Recall Campaign Bulletin

Mercedes-Benz

CAMPAIGN NO.	2025040012
CAMPAIGN DESC.	25P9192004
NHTSA ID	25V253
SUBJECT	Check Seat Belt Tensioner Cover
MODEL(S)	C-Class (206 platform)
MODEL YEAR(S)	2022 – 2025
CAMPAIGN POPULATION	46

Figure 1

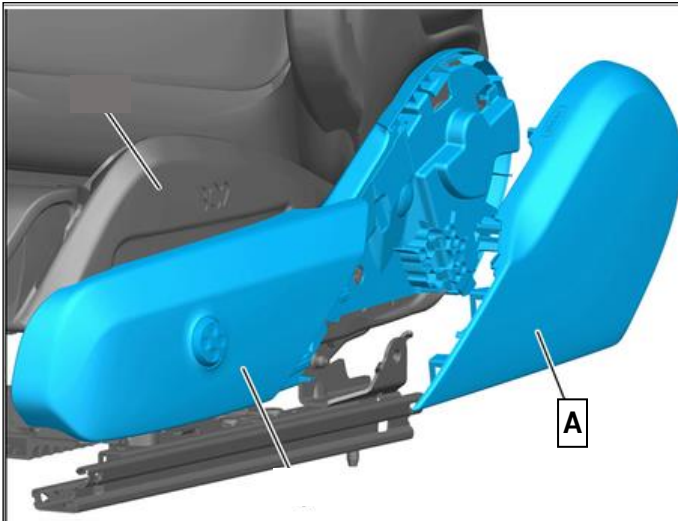
1. Remove the outer seat trim from the driver seat (**Figure 1, A**).

NOTE: Only the trim (**Figure 1, A**) needs to be removed!

Figure 2

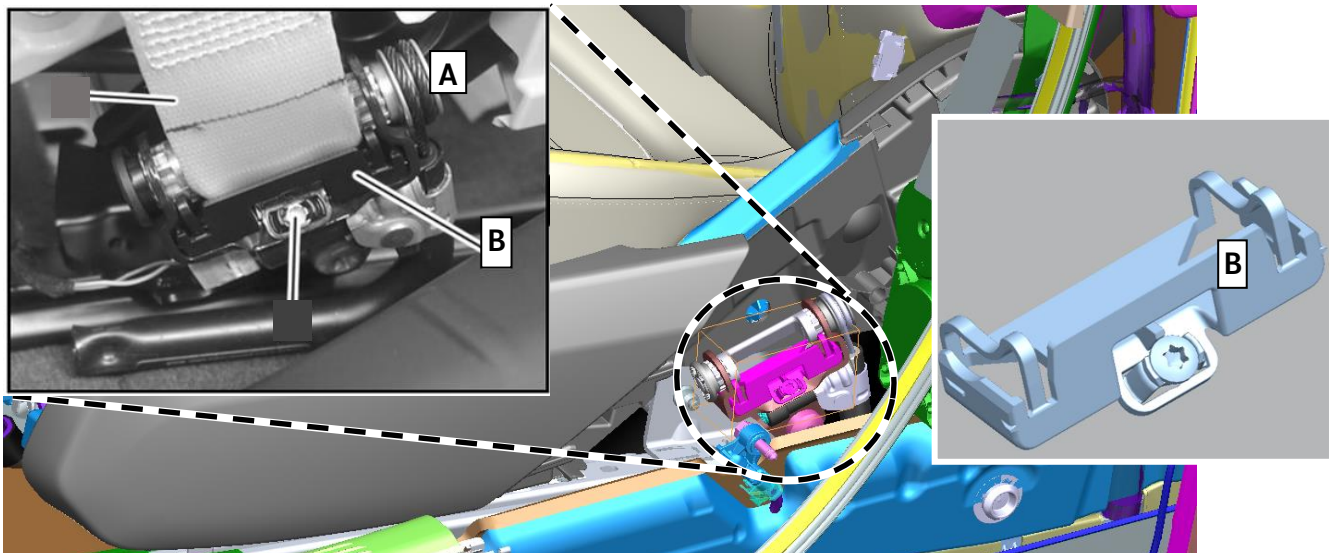
2. Check seat belt end-fitting (**Figure 2, A**) for correct installation.

i It is essential that the seat belt tensioner cover (**Figure 2, B**) is installed.

i The seat belt tensioner cover (**Figure 2, B**) could be missing from the vehicle.

- a. If the seat belt is not connected to the seat belt end-fitting tensioner (**Figure 2, A**) and/or the seat belt tensioner cover (**Figure 2, B**) is **not** installed: Carry out **Work Procedure**.
- b. If the seat belt end-fitting is installed correctly: **End measure**.

1. Correctly install seat belt end-fitting (**Figure 2, A**) and retrofit seat belt tensioner cover (**Figure 2, B**), if necessary.
i For basic data, see **AR91.40-P-1030-02LWE**.
 2. Assemble in reverse order
-
